# Access Compliance Report

## Public Rights-of-Way

Intersection ID: 42752	Main Street: ASHLEY_MEADOW_DR	Cross Street: SAWMILL_TRACE_DR	Location: S
ADA ID: C979AF5FB3A9	Ramp Type: PerpDiag	Initial Pass/Fail: Fail	Overall Compliance: No
Severity Score: 10			
Codes/Mitigation Info/Possible Solution		Field Measurements/Component Compliance

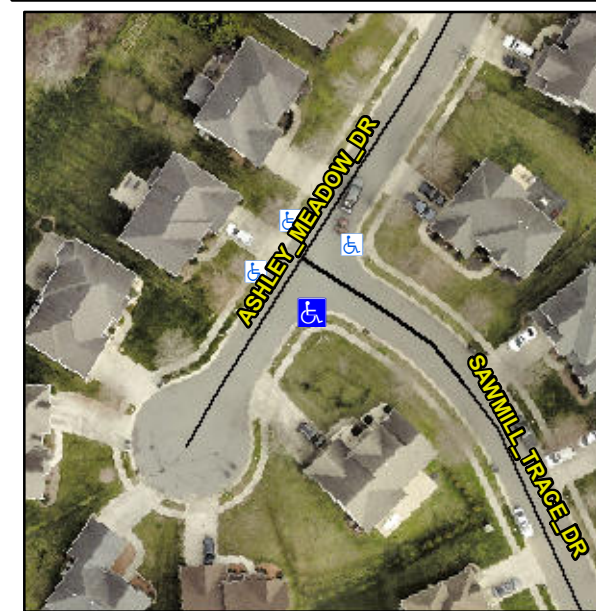
**Not Found, R304.5.1, R304.5.3**

Compliance	Description	Data	Compliance	Description	Data
N/A	Ramp Length (in)	52.0	Yes	Ramp Slope (%)	8.1
No	Ramp Width (in)	47.5	No	Ramp XSlope (%)	2.6
N/A	Flare Type LT	N/A	N/A	Flare Type RT	N/A
N/A	Flare Slope LT (%)	N/A	N/A	Flare Slope RT (%)	N/A
N/A	Flare Traversable LT?	N/A	N/A	Flare Traversable RT?	N/A
N/A	Landing Length (in)	N/A	N/A	DWS Provided?	N/A
N/A	Landing Width (in)	N/A	N/A	DWS Contrast?	N/A
N/A	Landing Slope (%)	N/A	N/A	DWS Length (in)	N/A
N/A	Landing X Slope (%)	N/A	N/A	DWS Full Width?	N/A
N/A	Landing Curb? (Y/N)	N/A	N/A	DWS Offset (in)	N/A
N/A	Shared Landing?	N/A			
N/A	Gutter Ponding?	N/A	N/A	Gutter Slope (%)	N/A
N/A	Gutter Lip Ht (in)	N/A	N/A	Gutter X Slope (%)	N/A
N/A	Painted X Walk1?	No	N/A	Painted X Walk2?	No
	X Walk 1 Direction	To NE		X Walk 2 Direction	To NW
N/A	X Walk 1 Width (in)	N/A	N/A	X Walk 2 Width (in)	N/A
	X Walk 1 Slope (%)	2.7		X Walk 2 Slope (%)	1.8
	X Walk 1 X Slope (%)	0.5		X Walk 2 X Slope (%)	3.7

**Remove & Replace Curb Ramp With Two New Directional Ramps or Equivalent.**
